Re: Protest to Application for
Federal Coal Lease UTU-64263

Re: Review of Cyprus-Plateau PHC Document

**REVIEW OF CYPRUS-PLATEAU STAR POINT MINE
PROBABLE HYDROLOGIC CONSEQUENCES DETERMINATION**

**HUNTINGTON-CLEVELAND IRRIGATION COMPANY
Huntington, Utah**

Well 92-01C-WD INJECTION TEST

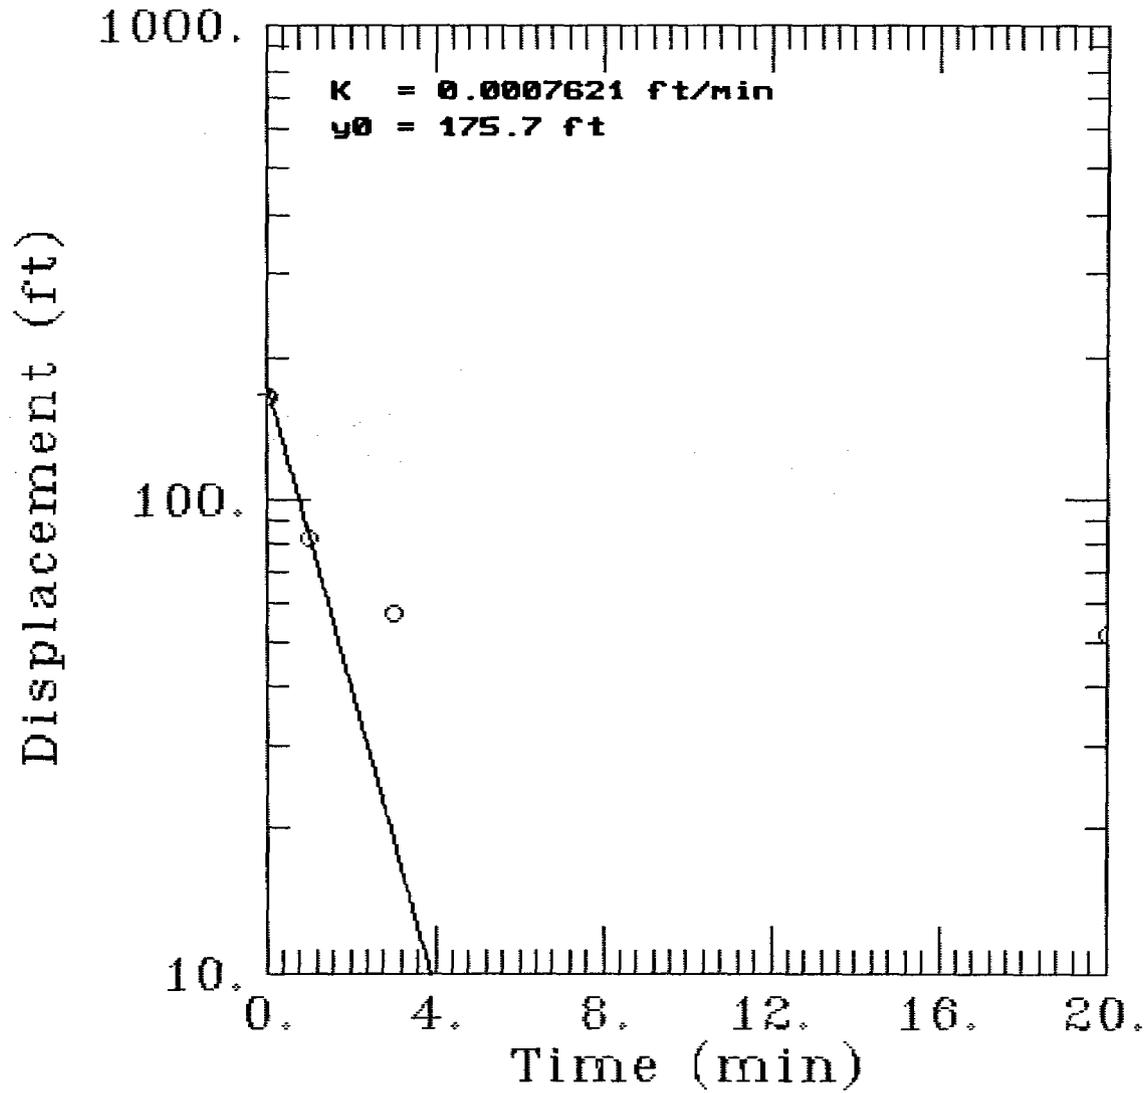
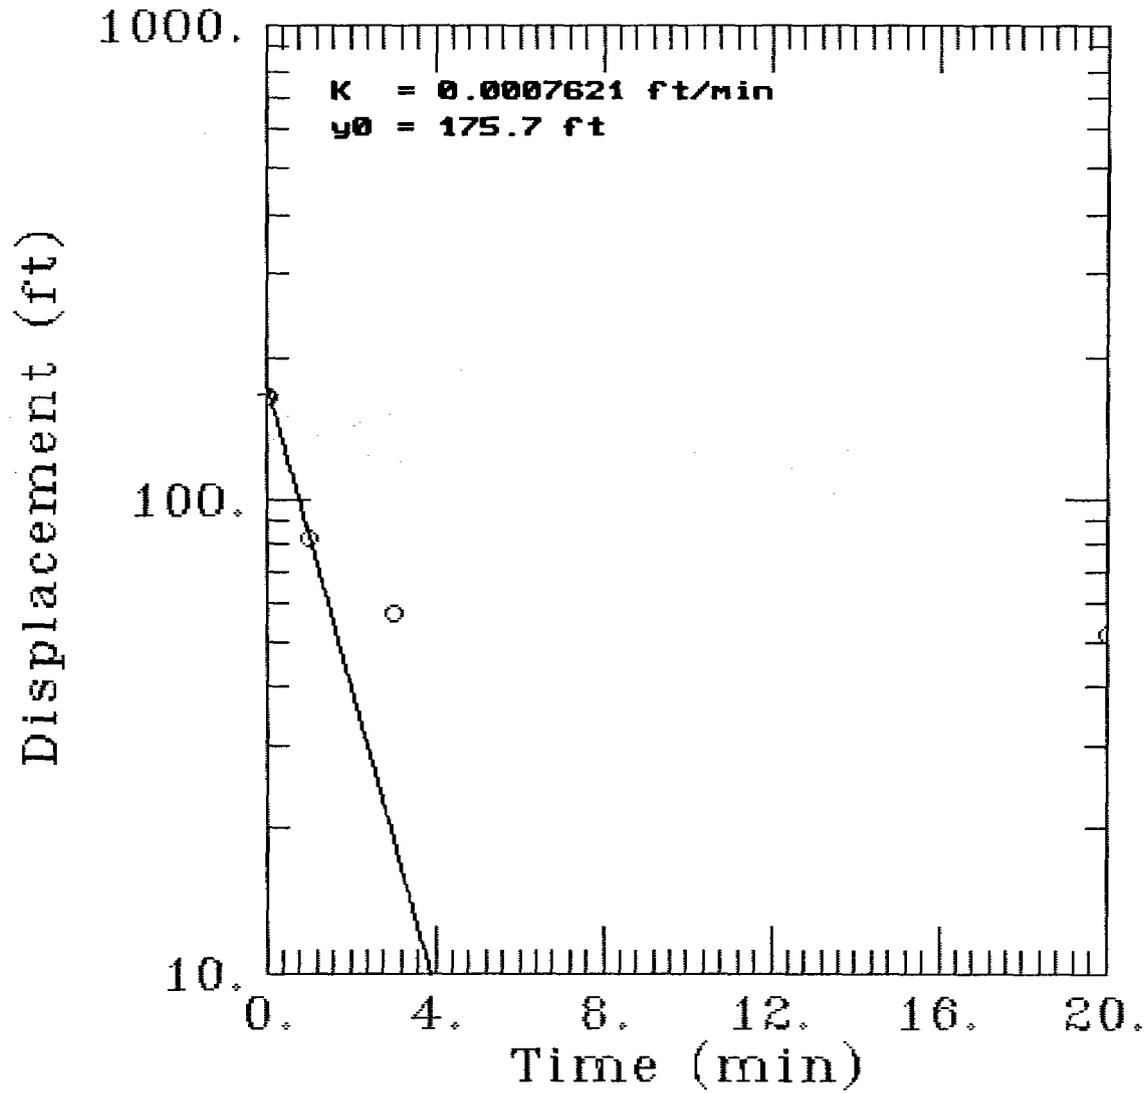
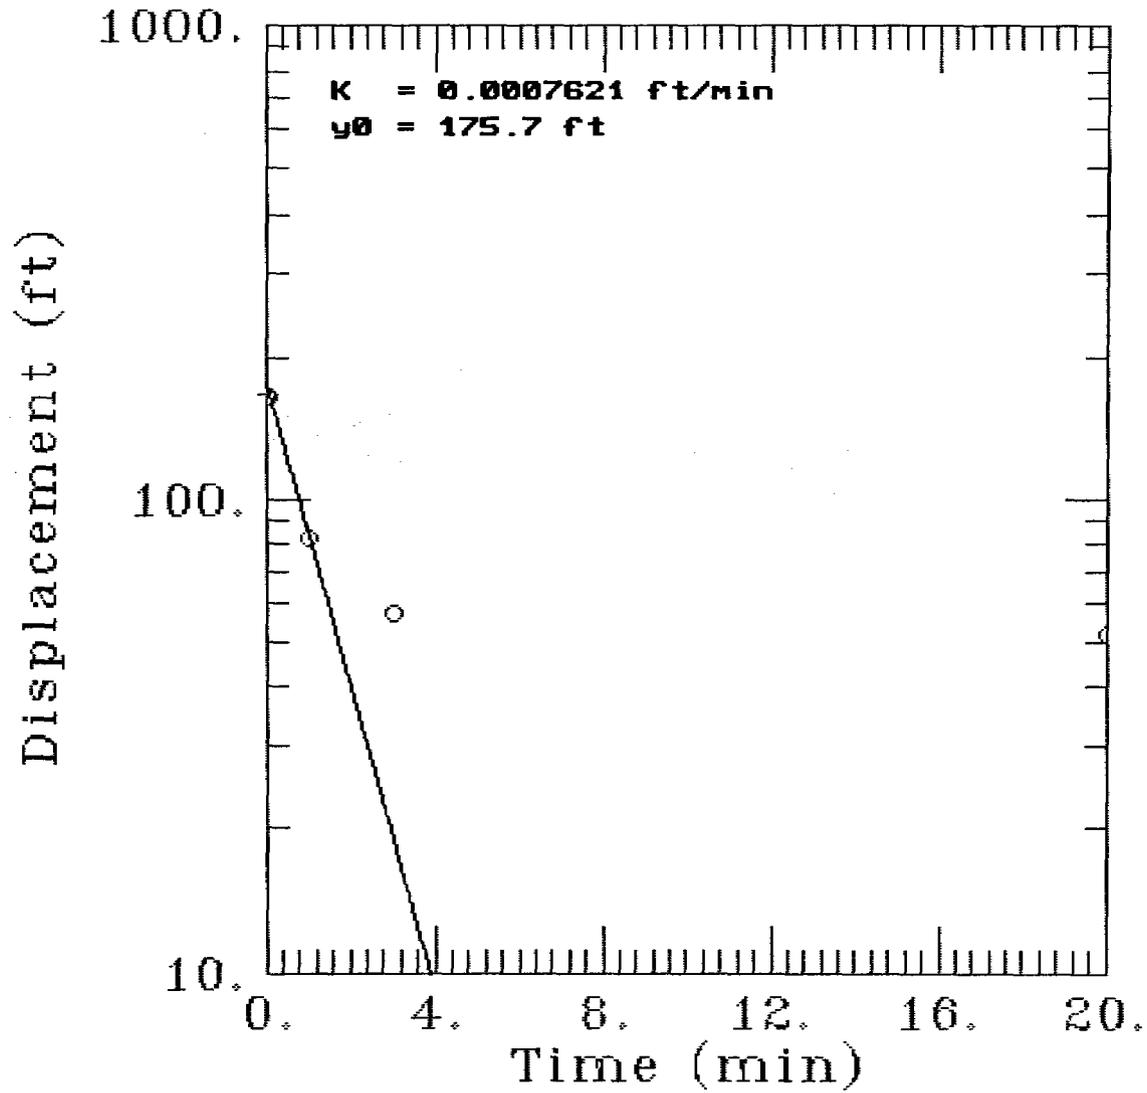
Additionally, there appear to be several problems associated with the slug test analyses. First, the K value (inaccurately identified as "permeability" in the text as opposed to "hydraulic conductivity") reported for well 92-02-WD in Table 728e does not correlate with the transmissivity (T) value for 92-02-WD listed in the output file in Exhibit 728c. The T value in the output file is reported as 8.1109^{-3} ft²/min. Transmissivity is converted to hydraulic conductivity by dividing the T value by the aquifer saturated thickness. The output file in

Third, according to the well completion diagrams in Exhibit 728b, wells 92-02-WD and 92-01C-WD were constructed with 2-inch diameter PVC pipe. Slug test analysis with AQTESOLV requires the input of casing and well radius in feet. The radius of 2-inch diameter PVC (in feet) is 0.0834. The value used by CPMC in the analyses of both wells was 0.17 feet, which roughly corresponds to the casing diameter. The radius or diameter of the well borehole is not shown in the completion diagrams. However, the diameter is indicated in the aquifer evaluation calculation sheet of Exhibit 728c. The well borehole diameter for both wells was also used instead of the well borehole radius. Such input errors in the AQTESOLV program would decrease the CPMC calculated hydraulic conductivity values, resulting in a more conservative estimate of hydraulic conductivity.

Re-analyses of the slug test data using the AQTESOLV program with the correct inputs for well construction, the time-drawdown data provided in the PHC, and the Bouwer and Rice method are presented in Appendix A of this review. Based on these re-analyses, the hydraulic conductivity values for the Spring Canyon slug tests are 7.62×10^{-4} ft/min (1.10 ft/day) and 8.54×10^{-5} ft/min (0.12 ft/day) for 92-01C-WD and 92-02-WD, respectively. These new values are lower than the reported values by a factor of approximately 3.5. As indicated previously, data were not provided for the remaining wells, thus not permitting re-analysis.

Well 92-02-WD Recovery Test

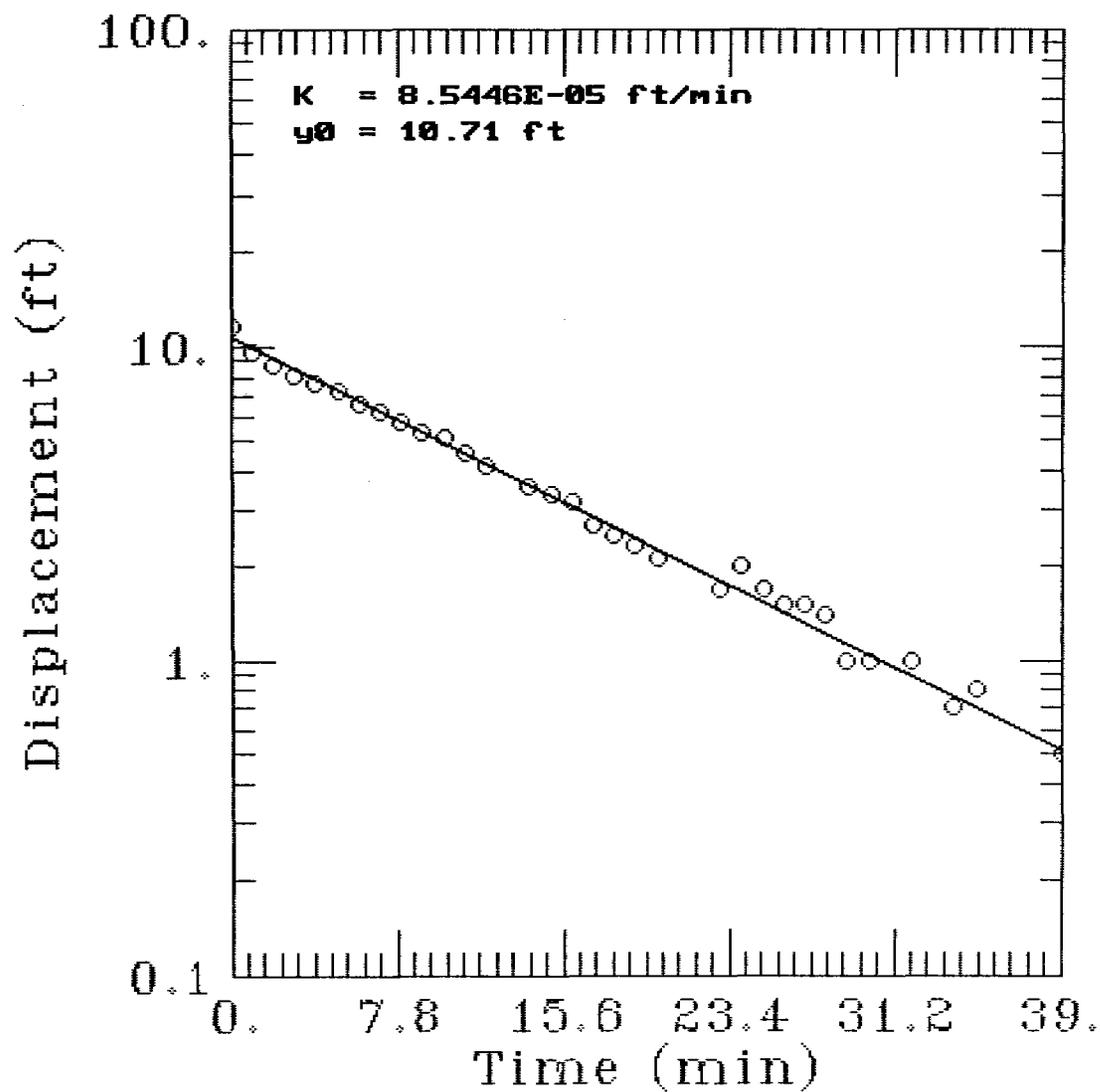
Exhibit 728c lists the aquifer saturated thickness as 194.8 feet. Therefore, the transmissivity (8.1109^{-3} ft²/min) divided by saturated thickness (194.8 feet) equals a hydraulic conductivity of 4.16^{-5} ft/min (0.06 ft/day). The hydraulic conductivity value presented in Table 728e for well 92-02-WD is 3.07^{-4} ft/min (0.44 ft/day).

Second, it appears that the plot for well 92-02-WD contained in Exhibit 728c represents a hand-fit unconfined Bouwer and Rice analysis plot of the slug test data, while the output file generated by the estimation procedure in AQTESOLV includes the constants for an unconfined Bouwer and Rice analysis and the title and residuals from a confined Cooper, et al. analysis. Therefore, the results of the analysis generated for this well are questionable. Based on the initial input data provided where the saturated thickness and the static height of water in the well are the same, the aquifer appears to be unconfined. Well logs and drilling records would be required to clarify the aquifer condition and these are not provided in the PHC. Therefore, it is difficult to evaluate the validity of the analysis.
